# UNITED STATES PATENT AND TRADEMARK OFFICE

APPLICATION NO.	FILING DATE	FIRST NAMED INVENTOR	ATTORNEY DOCKET NO.	CONFIRMATION NO.
10/707,775	01/12/2004	Michael Ronald Miller	140525	1774
23413	7590	12/12/2007		
CANTOR COLBURN, LLP 55 GRIFFIN ROAD SOUTH BLOOMFIELD, CT 06002			EXAMINER RAMIREZ, JOHN FERNANDO	
			ART UNIT 3737	PAPER NUMBER
			MAIL DATE 12/12/2007	DELIVERY MODE PAPER

**Office Action Summary**

## DETAILED ACTION

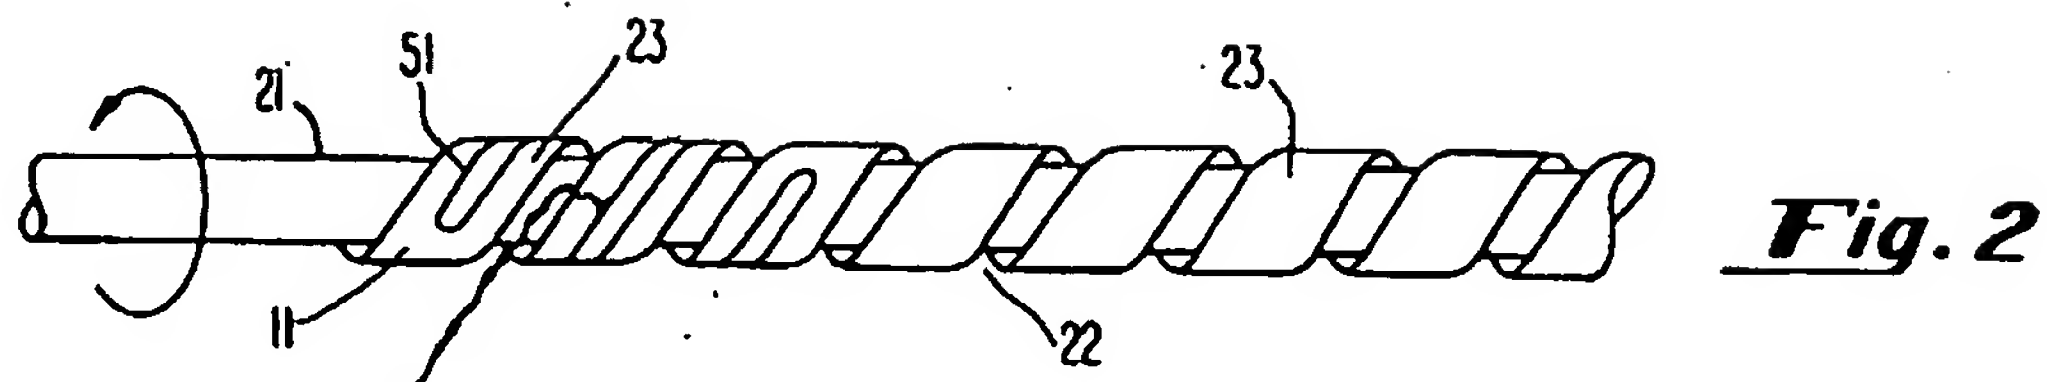
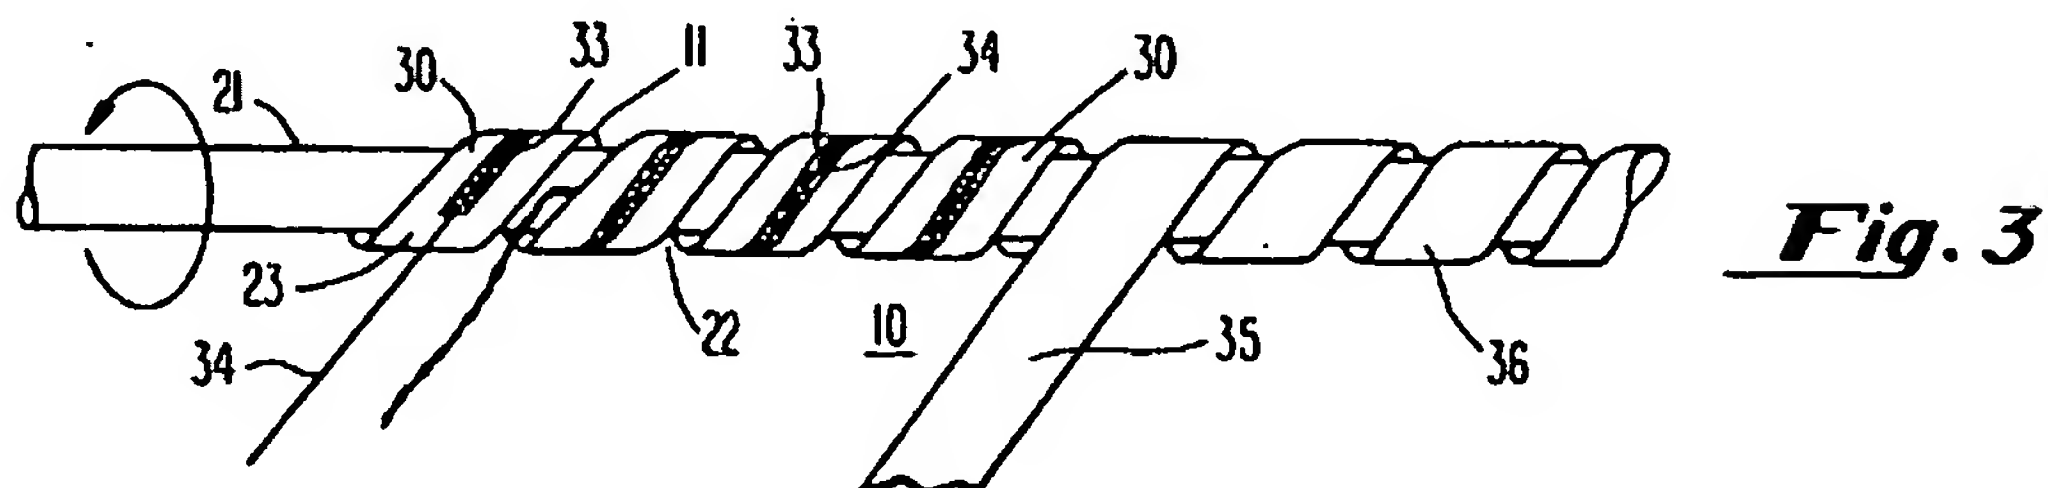
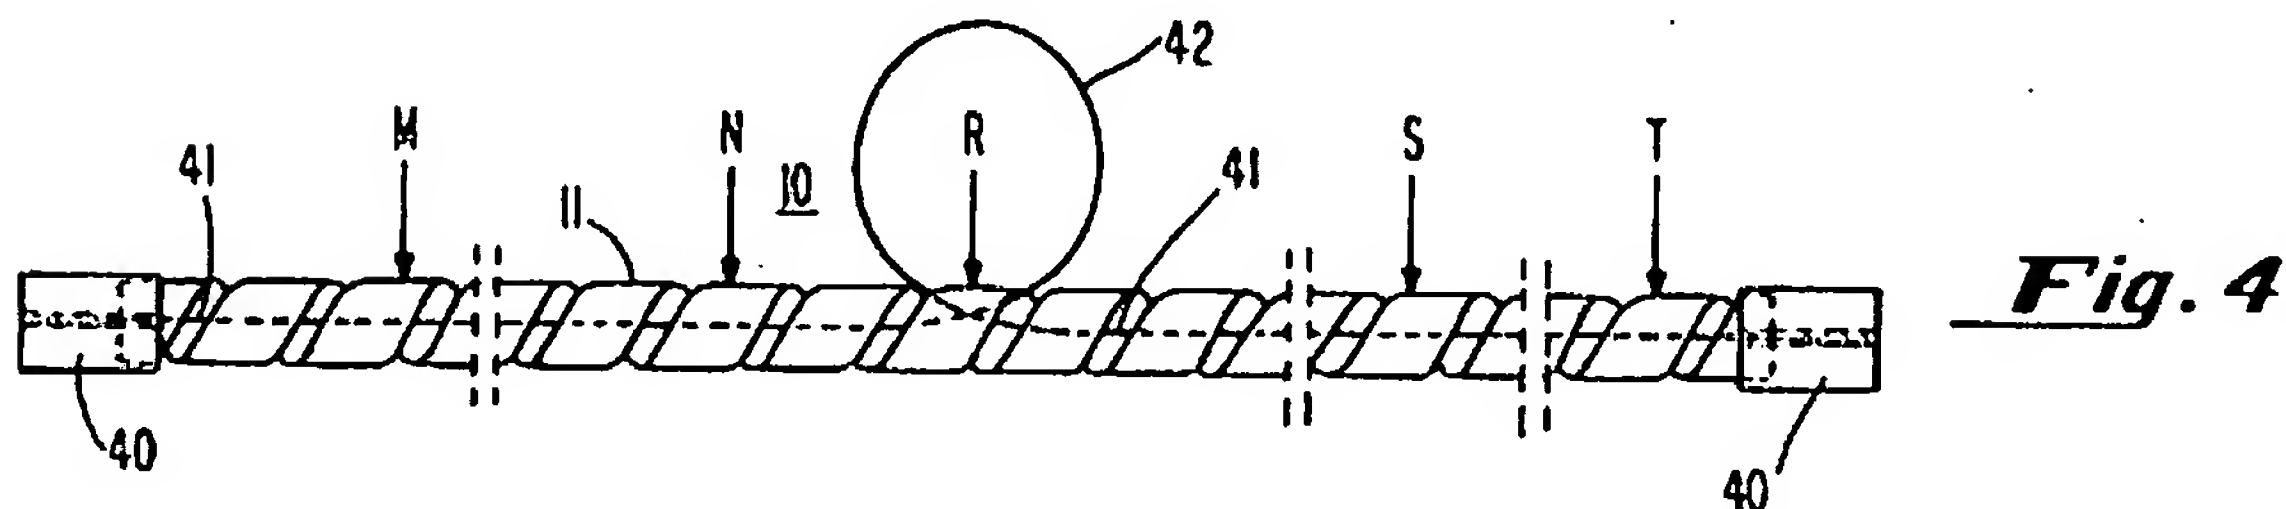
Figures 2, 3 and 4 above, illustrate the conventionality of the sensor is coupled to an end of the plastic cord. Additionally, the specification in column 5, lines 30-55, and in column 5, lines 7-29), expressly discloses a sensor that is coupled to an end of the plastic cord.

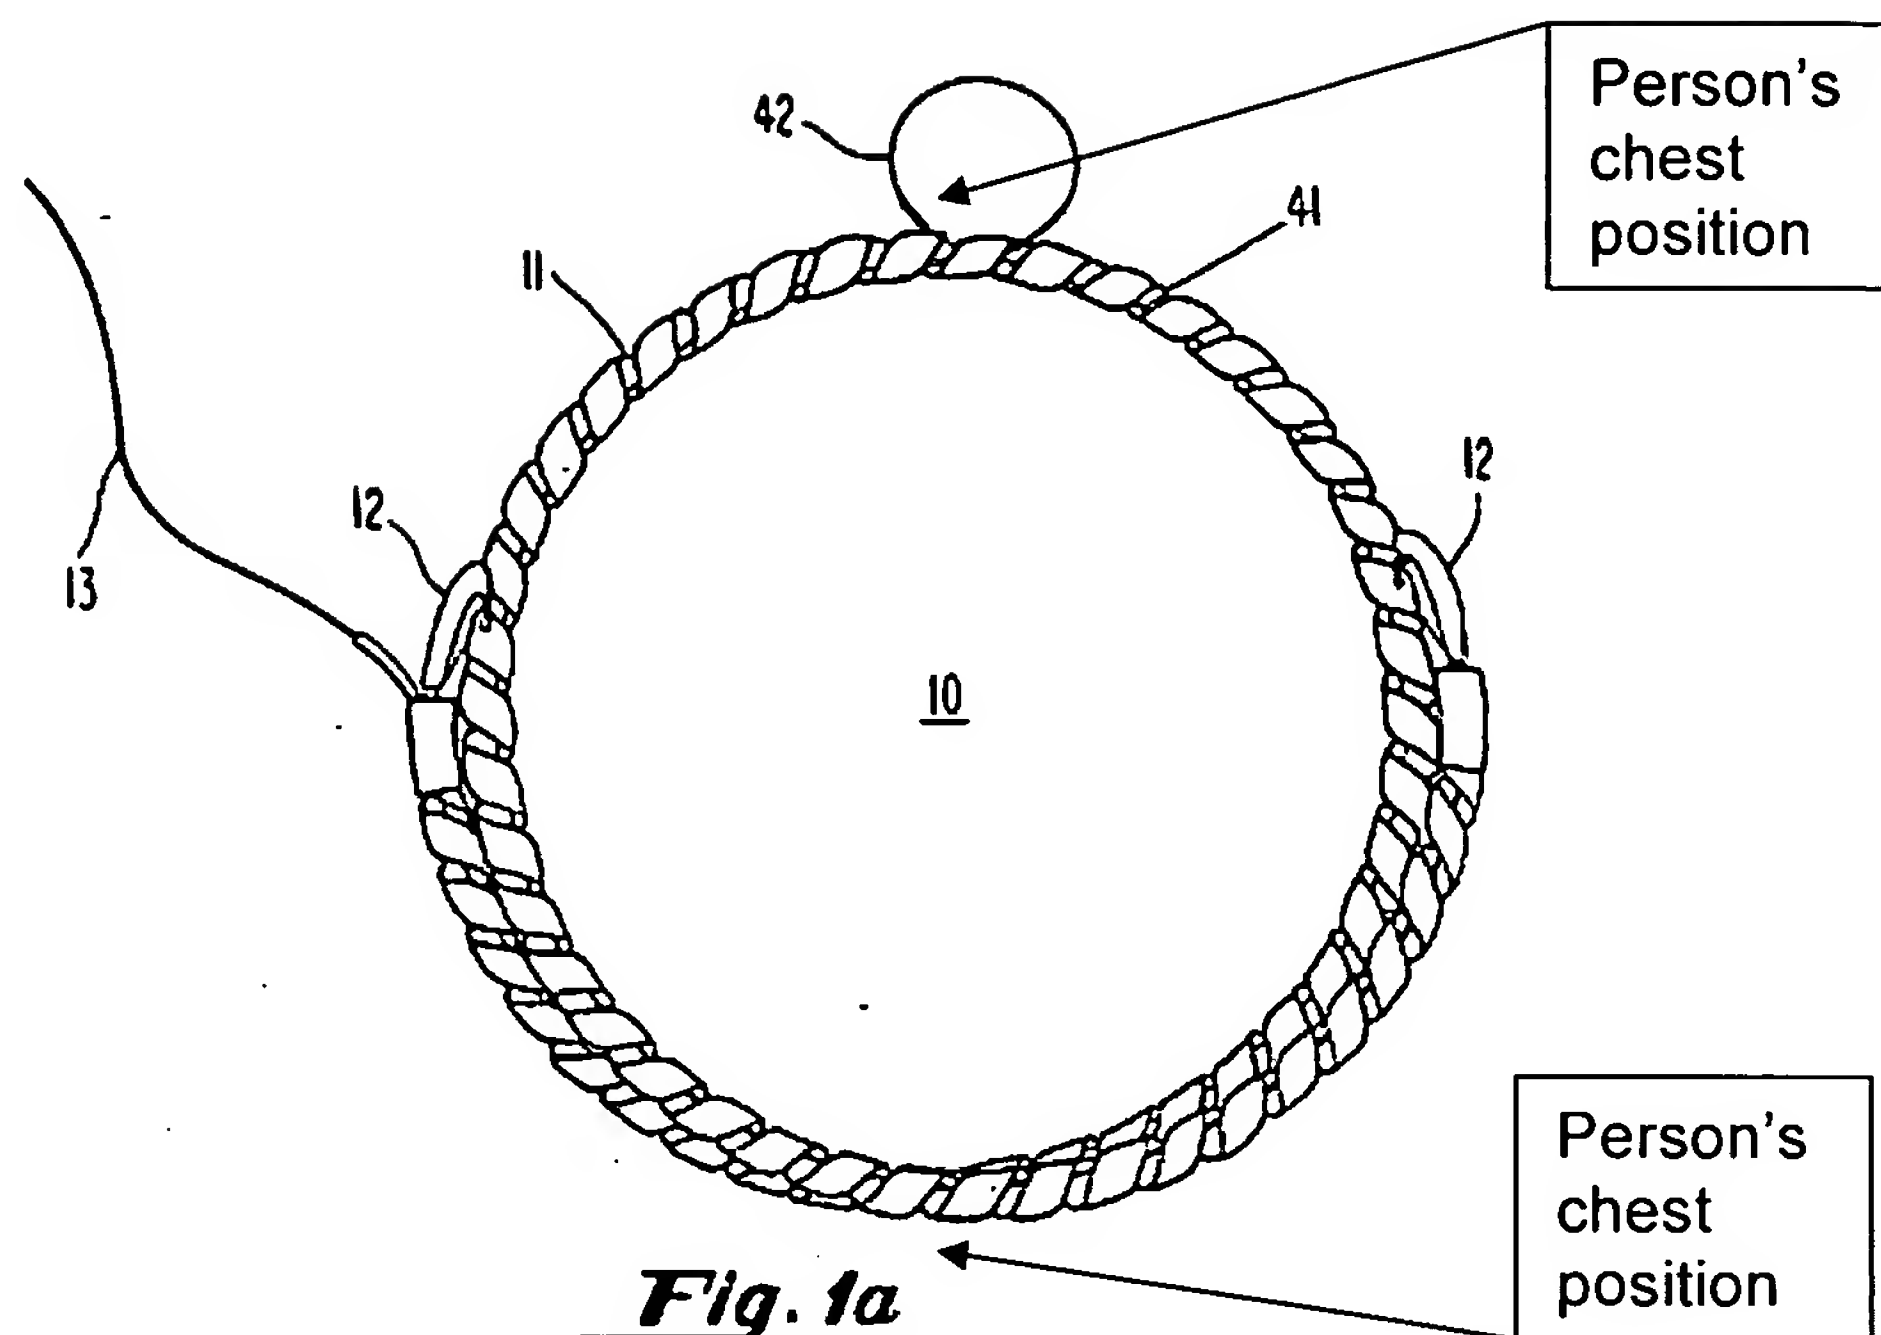
Figures 1a and 1b, illustrate the conventionality of the end of the plastic cord being configured to be disposed away from the chest of the person. In the specifications in column 4, lines 52-64, expressly discloses the end (12) of the plastic cord being configured to be disposed away from the chest of the person. As it can be seen from Figure 1a, the end (12) of the plastic cord (10) is disposed away from the chest. The position of the chest is either on the upper or lower portion of the spiral cord.
